SALEM GENERATING STATION UNIT NOS. 1 AND 2
FACILITY OPERATING LICENSES DPR-70 AND DPR-75
DOCKET NOS. 50-272 AND 50-311
CHANGE TO TECHNICAL SPECIFICATIONS
MARGIN RECOVERY PROGRAM

TECHNICAL SPECIFICATION PAGES WITH PROPOSED CHANGES

The following Technical Specifications for Facility Operating License No. DPR-70 (Salem Unit No. 1) are affected by this change request:

FIGURE 2.1-1 REACTOR CORE SAFETY LIMIT - FOUR LOOPS IN OPERATION

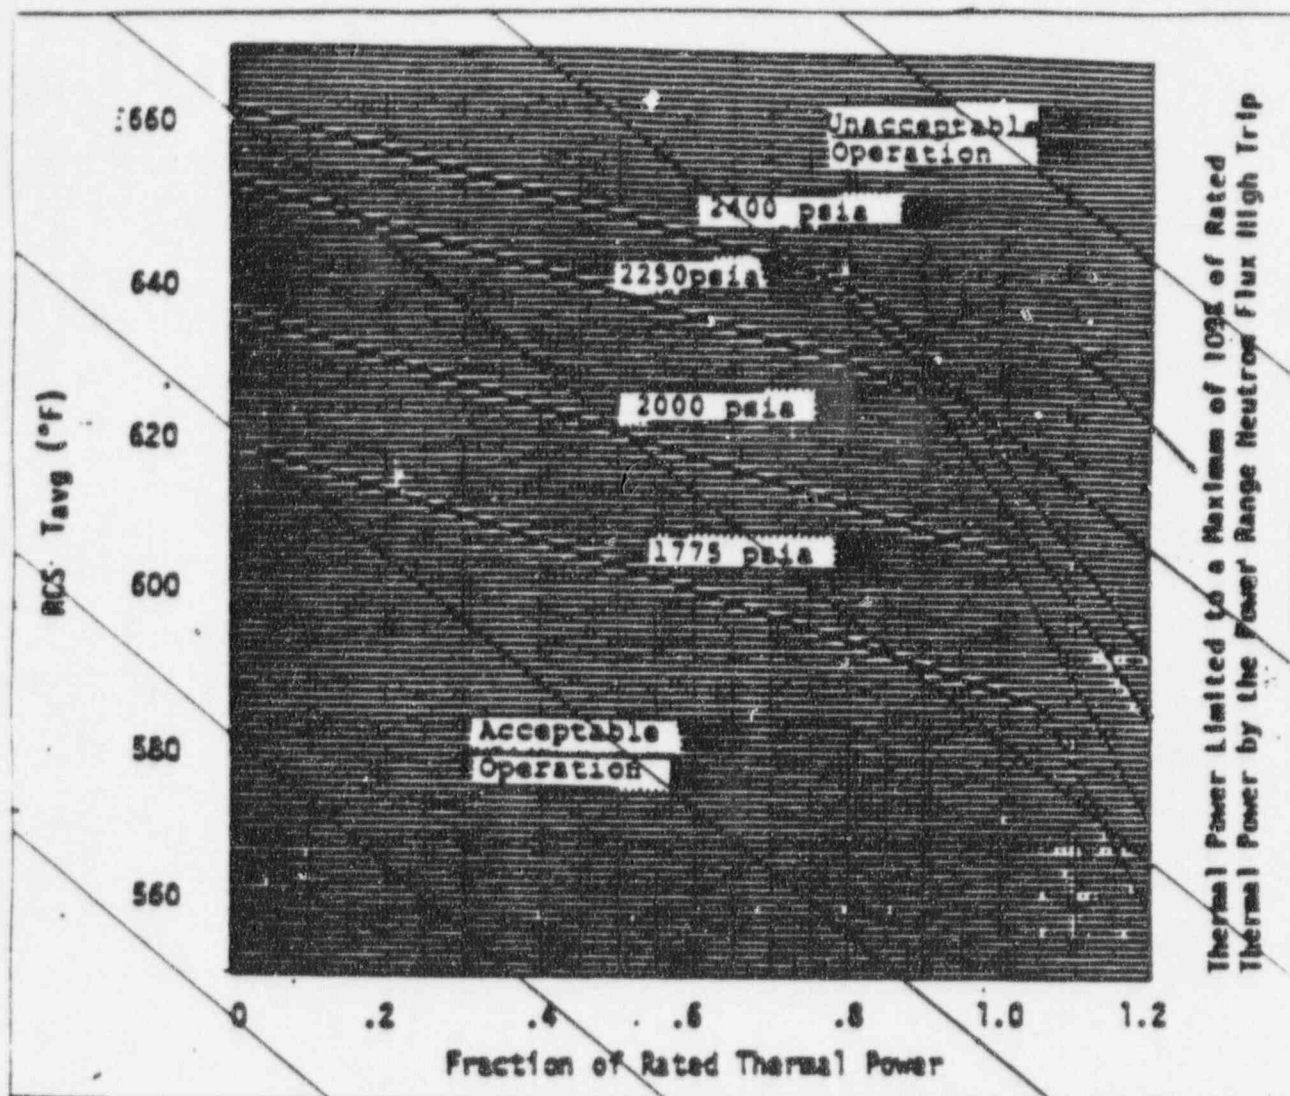
2.1.1 The combination of THERMAL POWER, pressurizer pressure, and the highest operating loop coolant temperature (T_{avg}) shall not exceed the limits shown in Figure 2.1-1 and 2.1-2 for 4 ~~loop~~ loop operation, respectively.

INSERT
HERE

FIGURE 2.1-2. REACTOR CORE SAFETY LIMIT - THREE LOOPS IN OPERATION

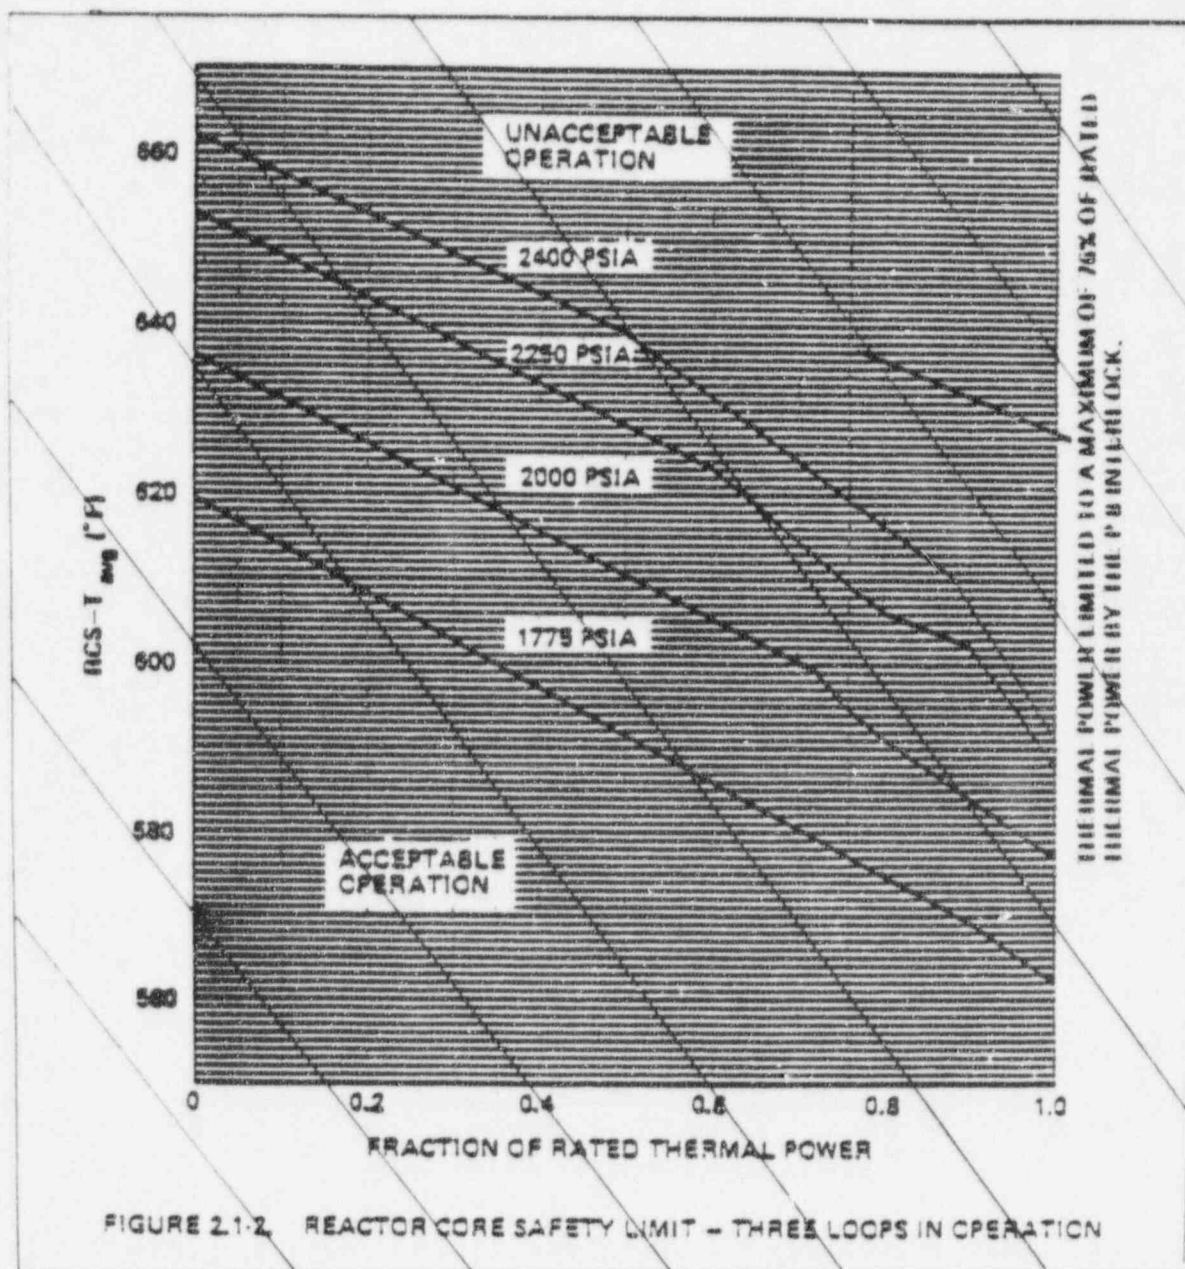
INSERT
B

REACTOR COOLANT SYSTEM PRESSURE FROM Pg 2-1

Figure B 3/4 2-1 TYPICAL INDICATED AXIAL FLUX DIFFERENCE
VERSUS THERMAL POWER

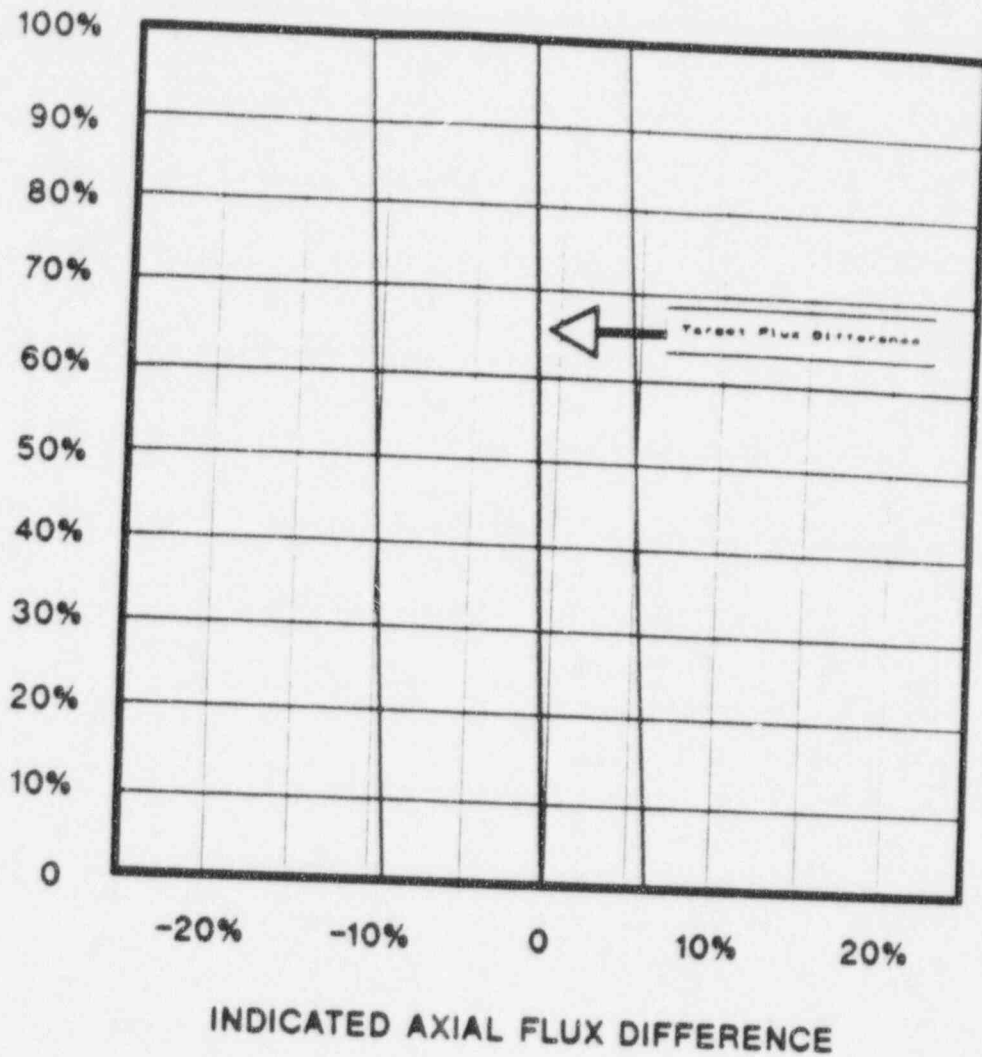
INSERT
G
HERE

INSERT
G

* REFER TO COLR FIGURE 2 FOR
ACTUAL LIMITS

FIGURE 2.1-1 REACTOR CORE SAFETY LIMIT - FOUR LOOPS IN OPERATION

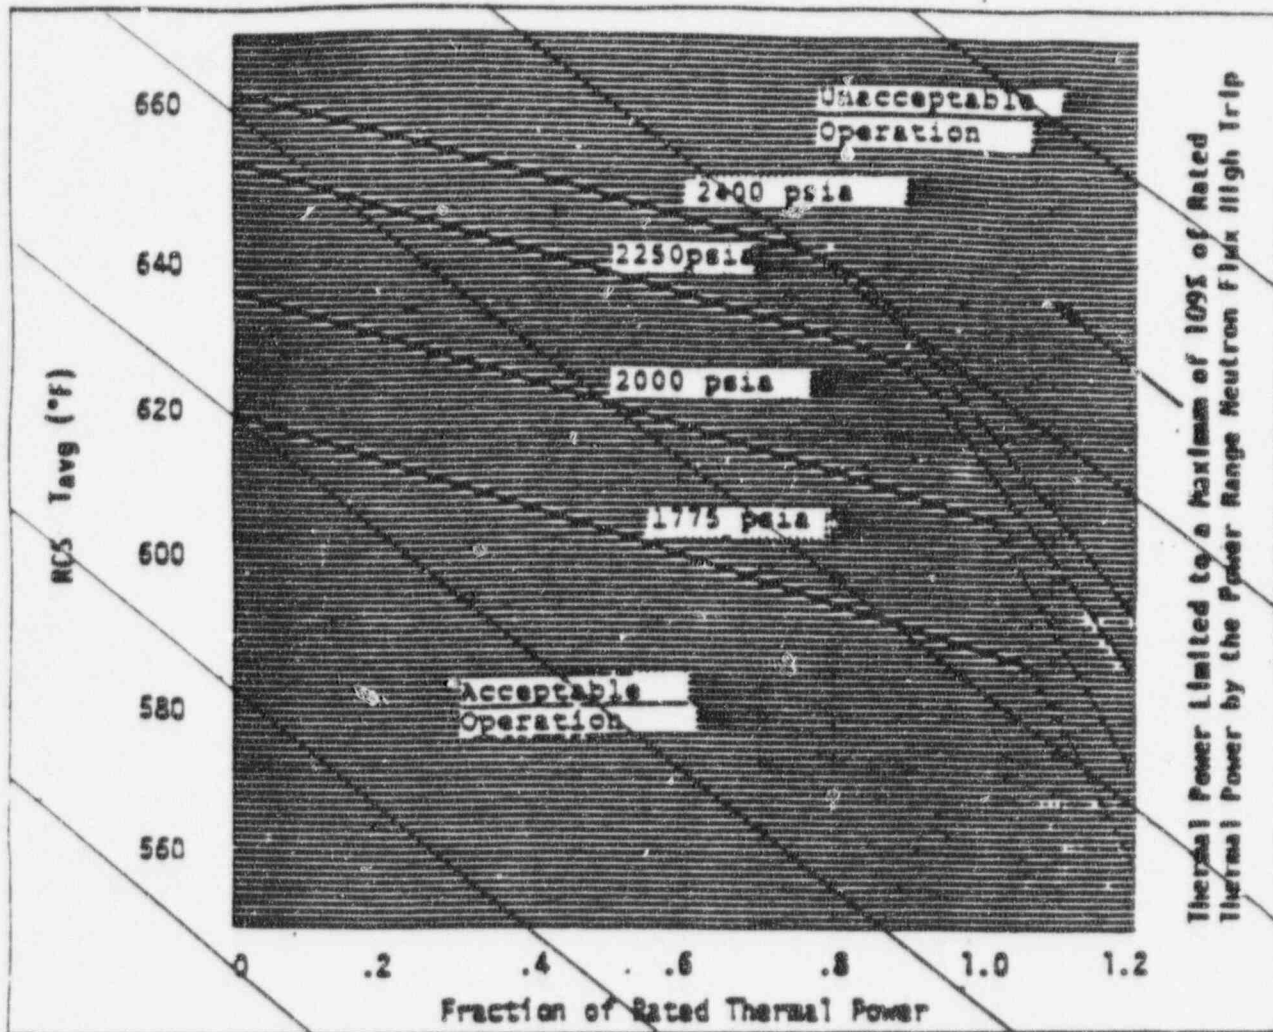
INSERT
HERE

FIGURE 2.1-2 REACTOR CORE SAFETY LIMIT - THREE LOOPS IN OPERATION

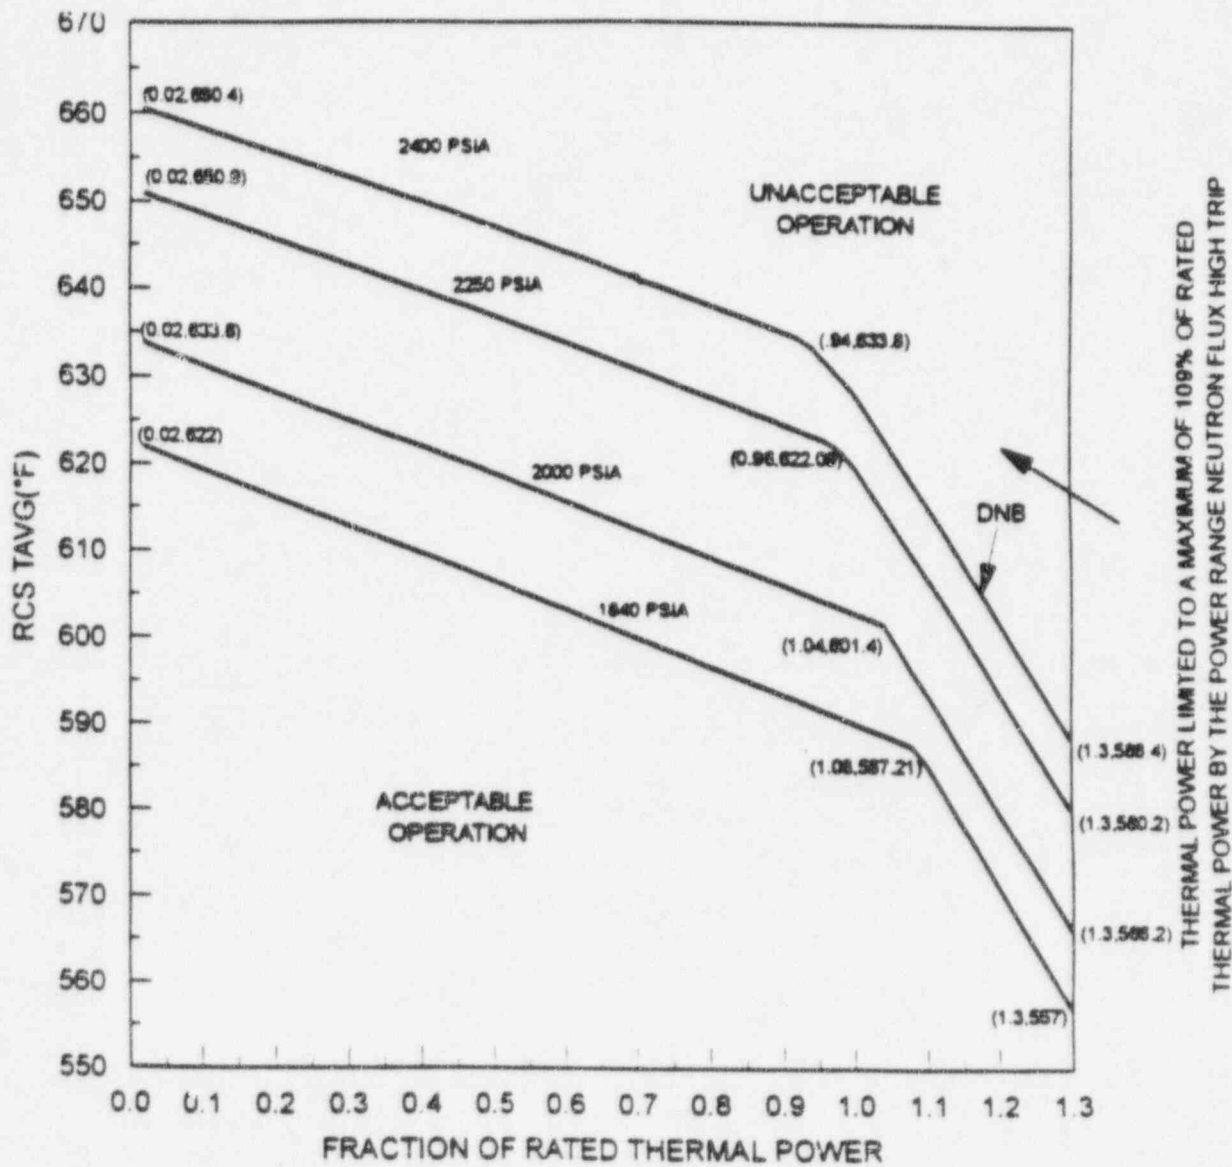
INSERT B

FIGURE 2.1-2 INTENTIONALLY LEFT BLANK PENDING

Figure B 3/4 2-1 TYPICAL INDICATED AXIAL FLUX DIFFERENCE
VERSUS THERMAL POWER

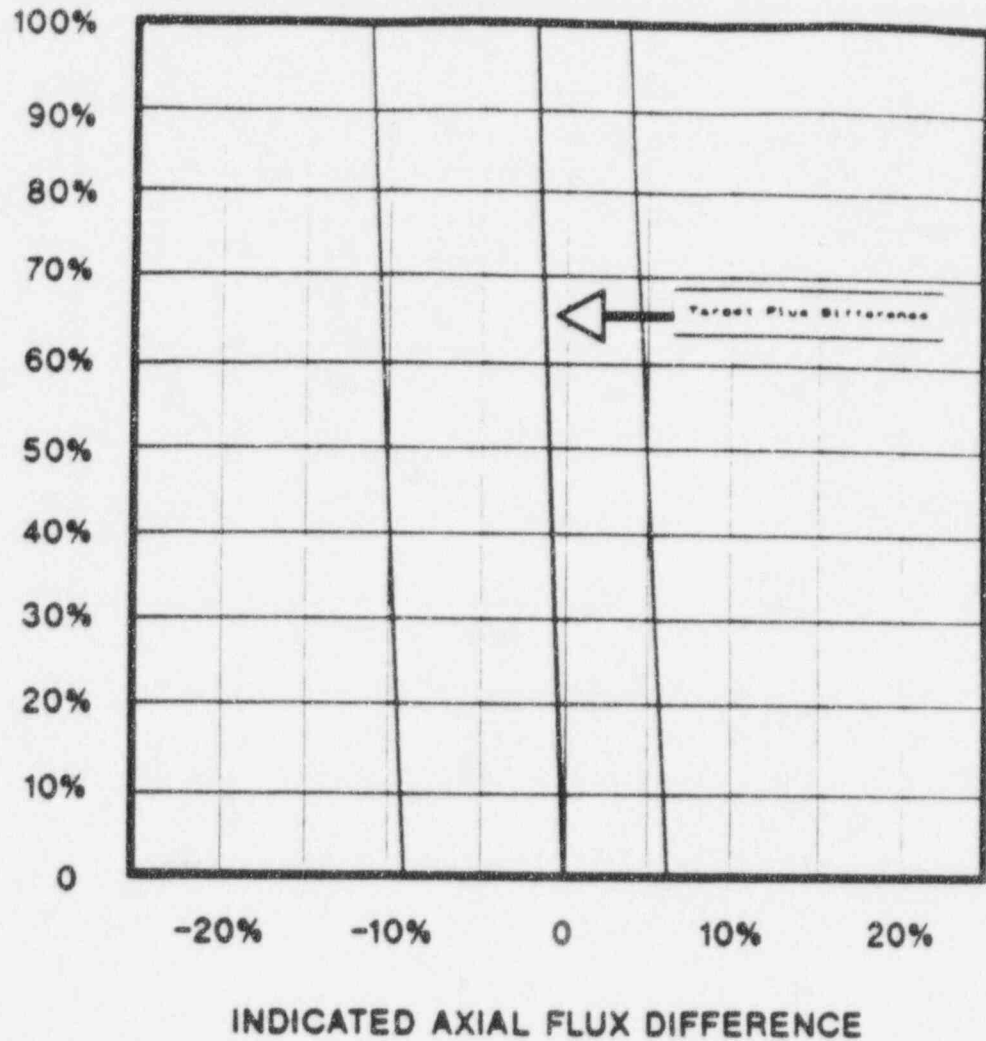
INSERT G HERE

INSERT
G

* REFER TO COLR FIGURE 2 FOR
ACTUAL LIMITS
